ONTARIO ENERGY BOARD

AND IN THE MATTER OF an Application by Hydro One Networks Inc. pursuant to section 92 of the Act, for an Order or Orders granting leave to construct a transmission reinforcement project between the Bruce Power Facility and Milton Switching Station, all in the Province of Ontario.

EVIDENCE OF THE INTERVENOR THE SAUGEEN OJIBWAY NATIONS

AFFIDAVIT

Figure 1
Hydro One Transmission Capacity with Near-Term Upgrades and New Line

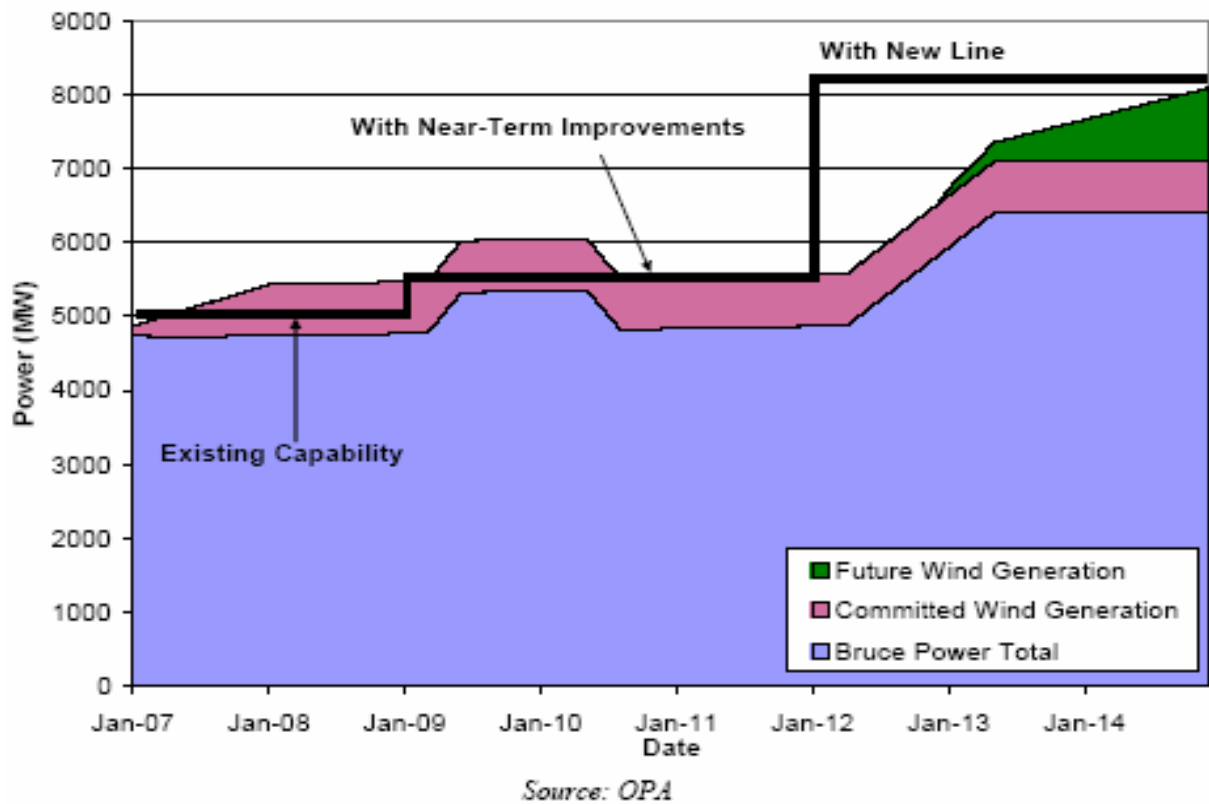
9. It is critical to note that in its assessment of the need for its proposed project, Hydro One, relying on OPA analysis and reports, has included two significant sources of generation that have not been approved or committed. First, Hydro One has included 1000 MW of potential wind generation from the Bruce region that has been identified in the IPSP. Second, Hydro One has included in its analysis 4 refurbished Bruce B units with an estimated combined output of approximately 3400 MW. The inclusion of these two unapproved and uncommitted sources of generation has fundamental implications both as a justification for the proposed project from a system design perspective, as well as for the economic evaluation of the project and other reasonable alternatives.

10. A proper need analysis ought to be based on existing and committed generation from the Bruce area. Removing the two major sources of unapproved and uncommitted generation that have been included in Hydro One’s analysis results in a picture of the transmission facilities that are required to service the Bruce area dramatically different from that conveyed by Hydro One. This difference is evident when comparing Hydro One’s graphic representation of the need for the new line, shown in Figure 1, to my analysis, shown as Figure 2. As can be seen in Figure 2, the amount of generation that needs to be accommodated in the Bruce area never exceeds 7000 MW, using actual existing ratings and removing uncommitted generation.

Figure 1: Bruce Area Available Generation (2007 – 2014)

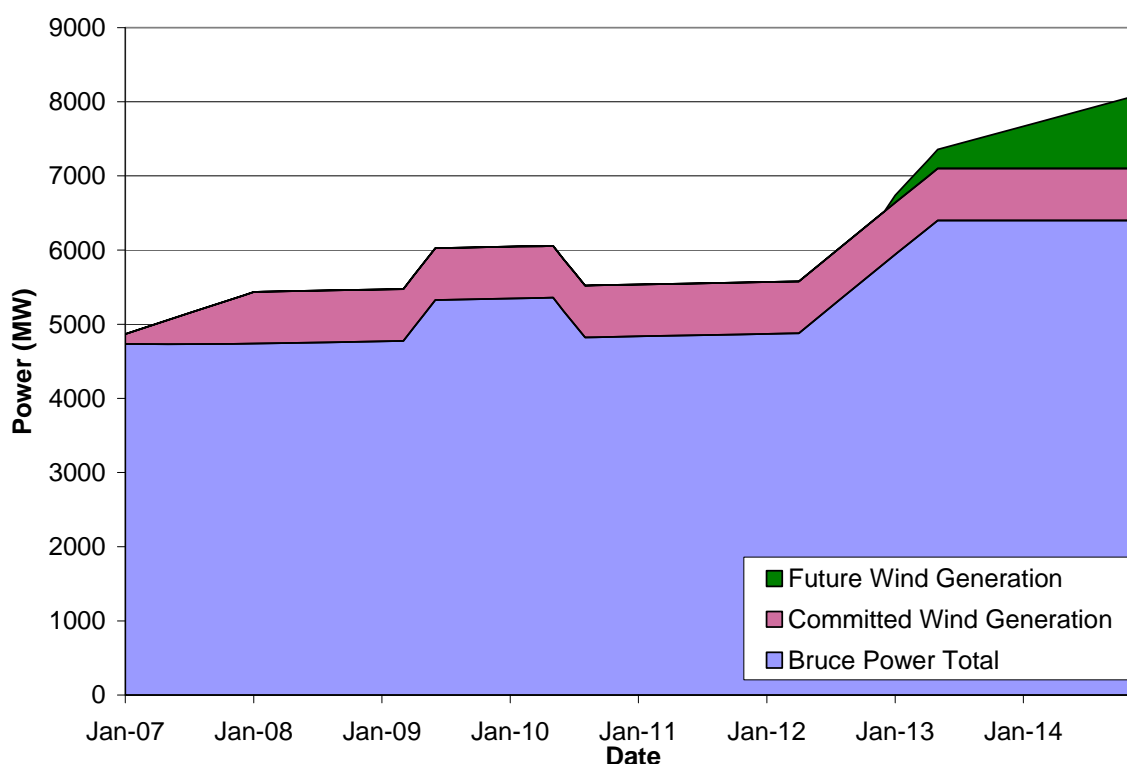
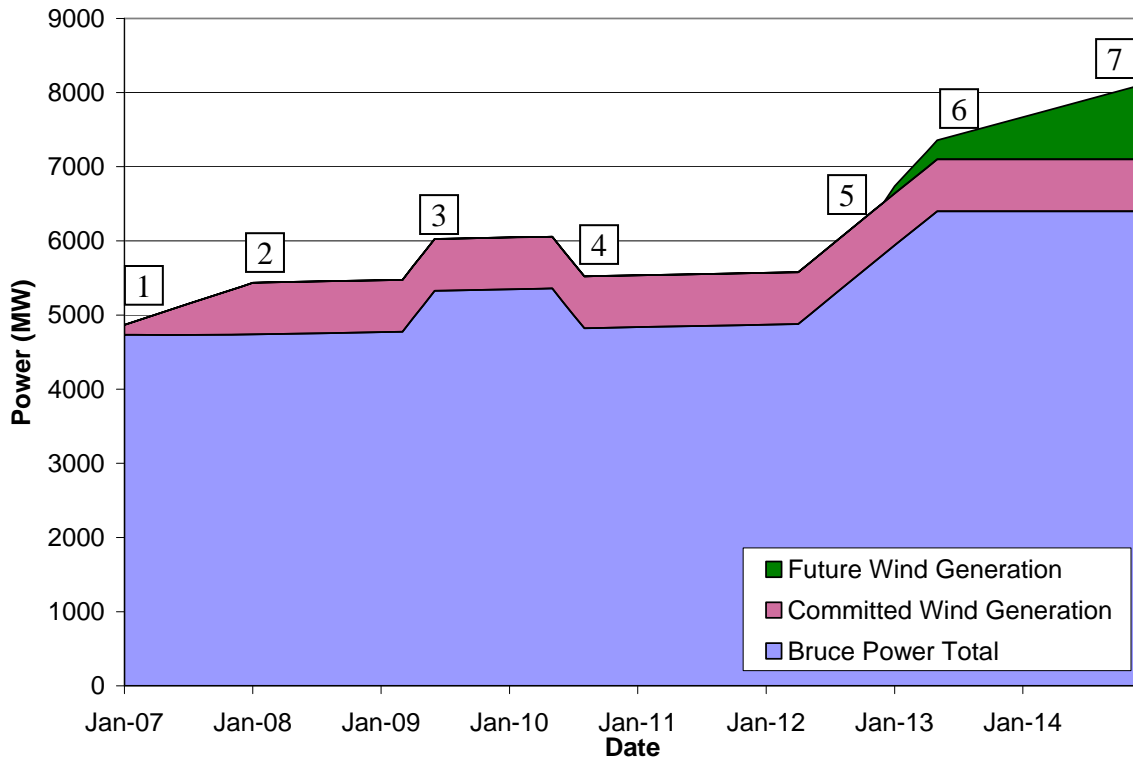
It appears from Figure 1: Bruce Area Available Generation (2007-2014) that there may be “700” additional megawatts of electricity planned to be transmitted from the Bruce site in 2009 with precisely the same amount of electricity being reduced in early 2010, and not recaptured until 2012. Why is this transmission project being initiated in 2008 and its approval expedited over the next few months when there is no effective, lasting demand for such a transmission project until 2012 – which also assumes no effective provincial CDM initiatives are in play?

In Figure 1 referenced above, the net increase in the amount of Bruce Area generation above today’s 4,800 MW level is forecast to increase in the future. The shortfall in transmission capability is forecast to be about (please refer to the figure reproduced below):

1. 0 MW in early 2007 (Existing System, only six units in-service at Bruce NGS)
2. 500 MW in 2008 (Committed Wind goes in-service)
3. 1,000 MW in 2009-2010 (Bruce A units 1 and 2 return from refurbishment before Bruce A units 3 and 4 are removed from service for refurbishment)
4. 500 MW in 2011 (Both units 3 and 4 are being refurbishment)
5. 1,500 MW in 2012 (Bruce units start returning from refurbishment)
6. 2,600 MW in 2013 (All eight Bruce units are in-service, planned wind starts coming in-service)
7. 3,100 MW in 2014 (All eight Bruce units are in-service; most of the planned wind is in-service)

The capability of the existing Bruce transmission system is about 5,000 MW. While the proposed near-term measures will increase the capability to 5,400 MW, this is still far short of the capability required in 2009 of 6,000 MW total. Thus, the need for long-term reinforcement of the Bruce transmission system exists in 2009. Until this reinforcement (the Project) is in place, interim stop-gap measures must be used, such as generation rejection and continuation of the OPA moratorium under the Standard Offer Program with regard to granting power purchase contracts for generation developments in the Bruce Area.

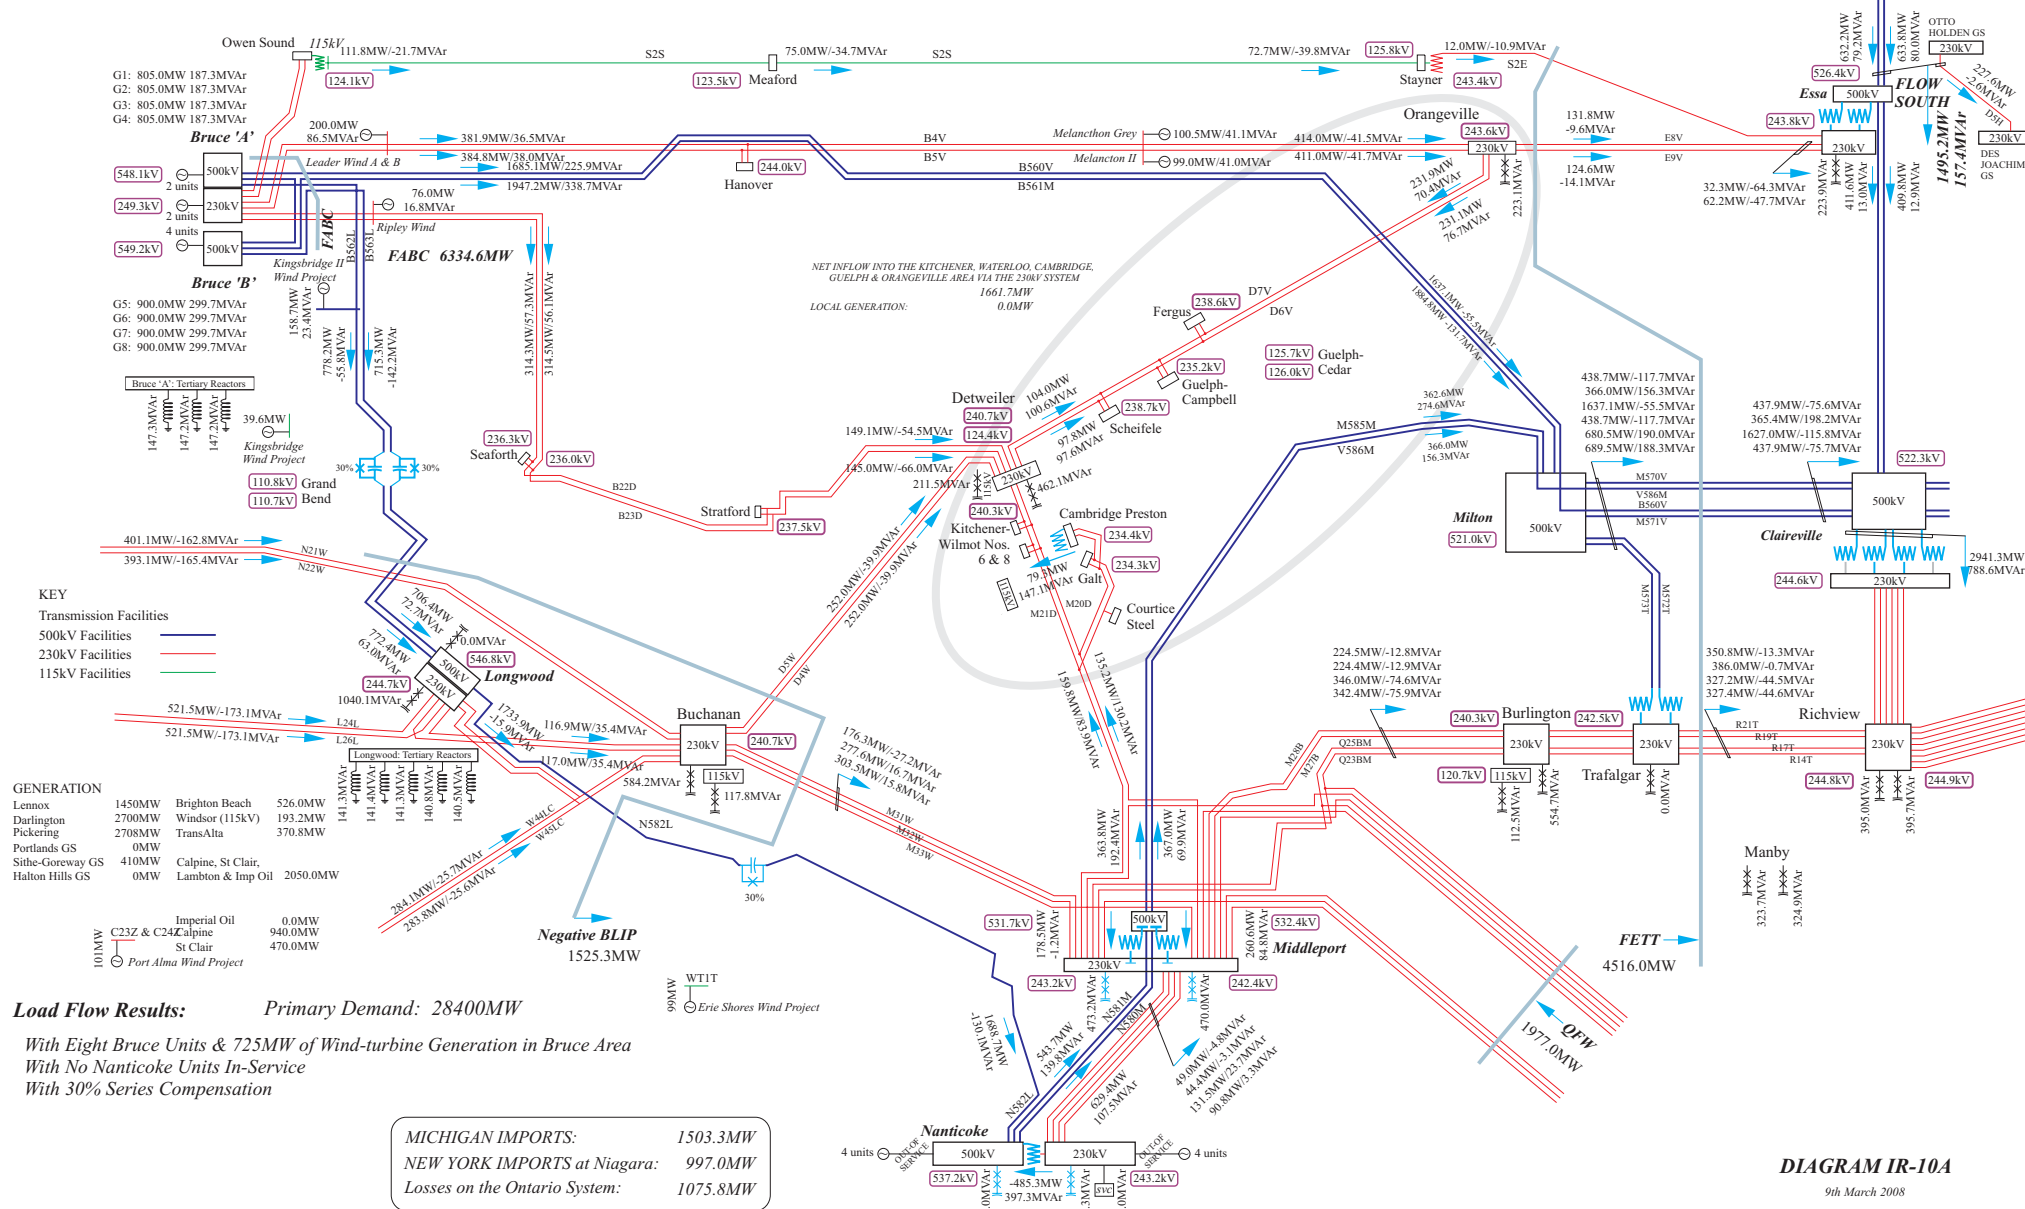
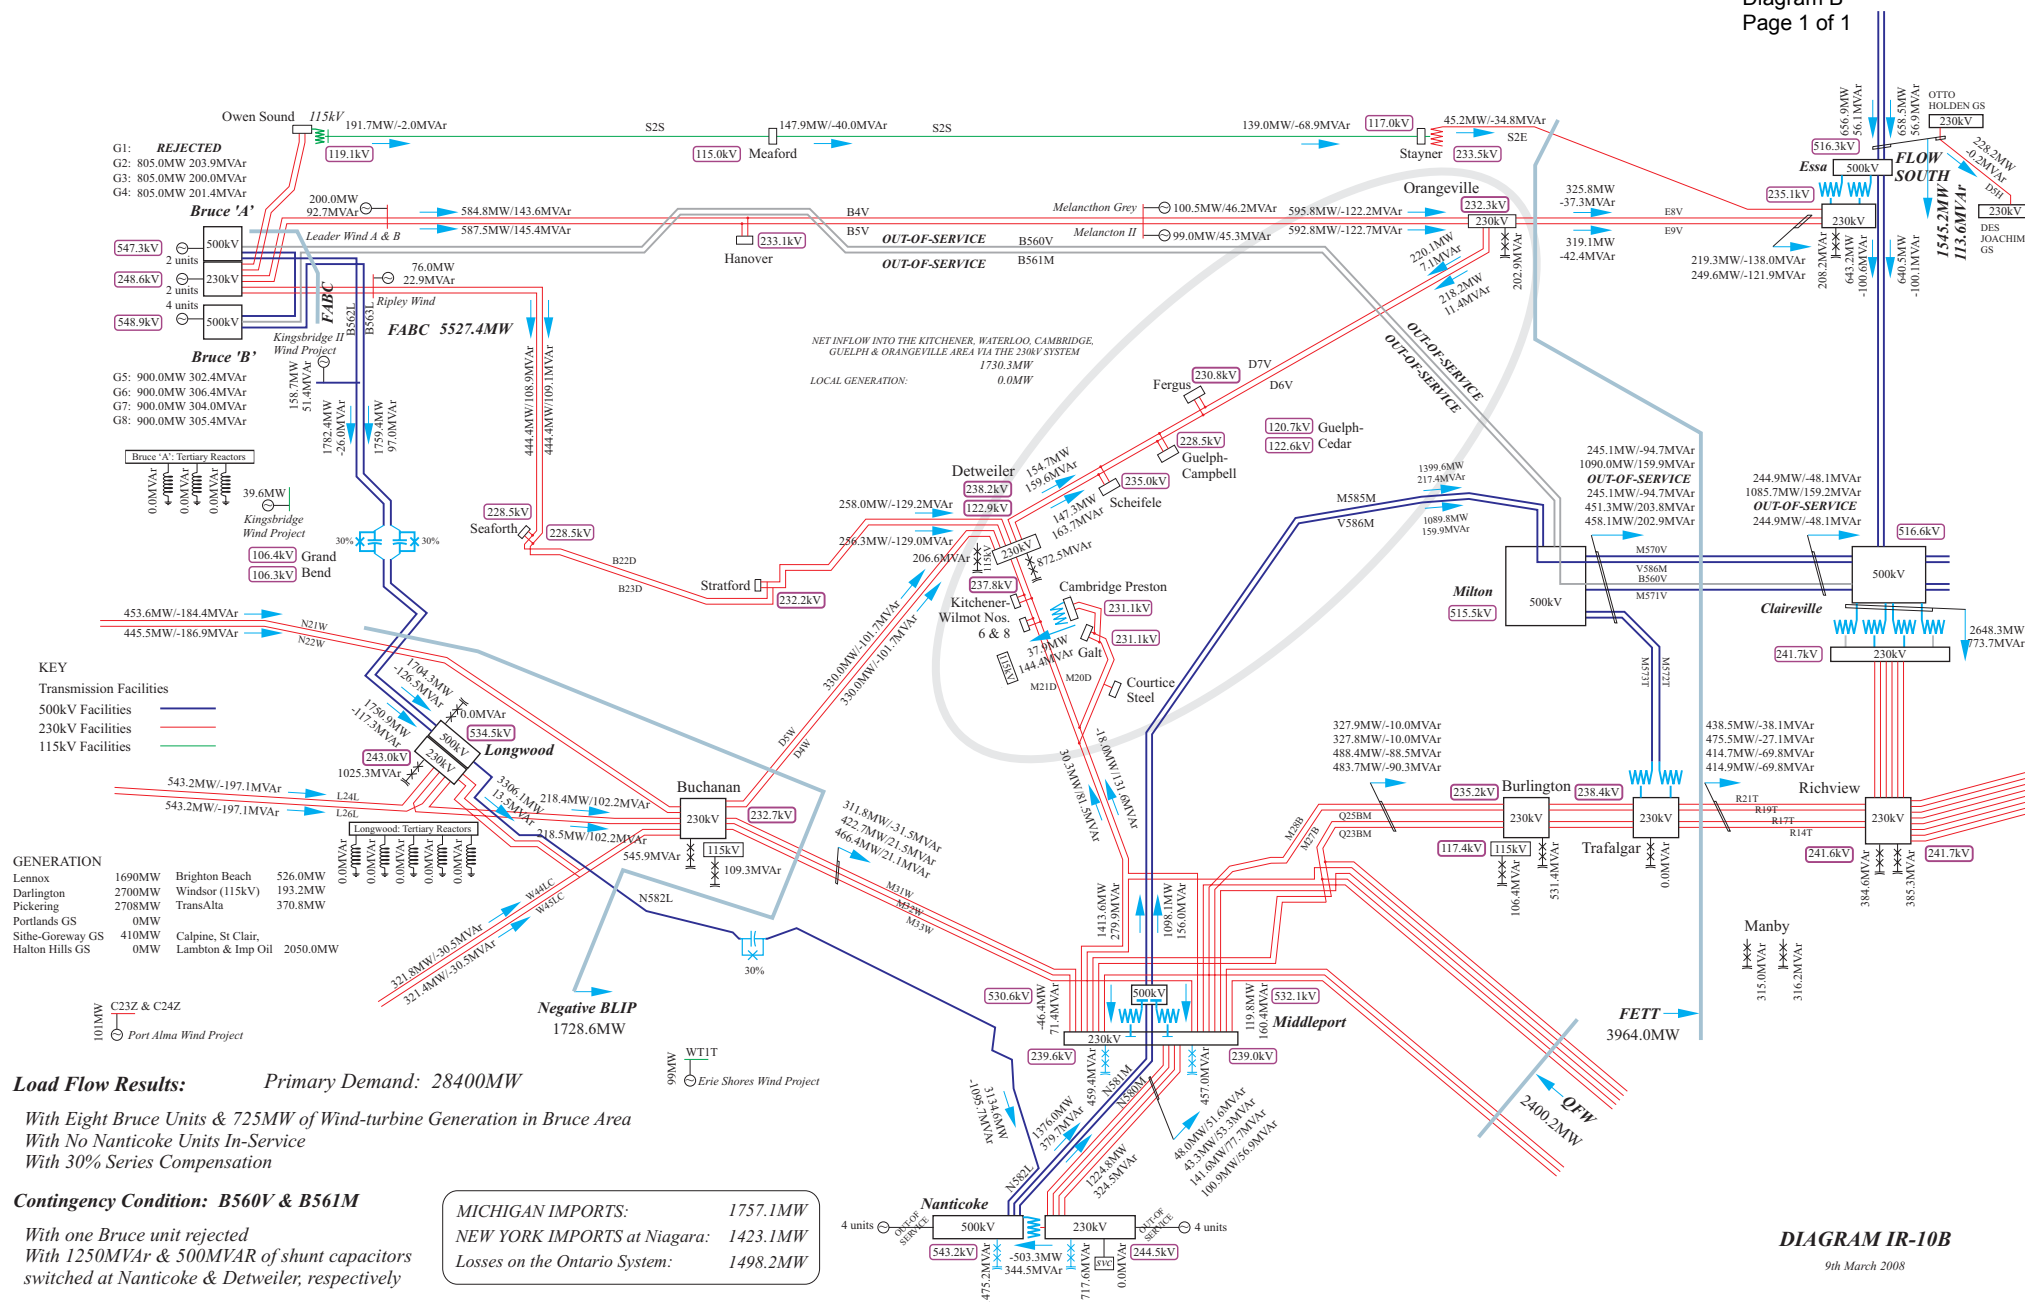
The results of the load flow study for the pre- & post-contingency conditions with series capacitors installed and with a single unit at the Bruce Complex rejected are shown in the attached Diagrams A & B, respectively.
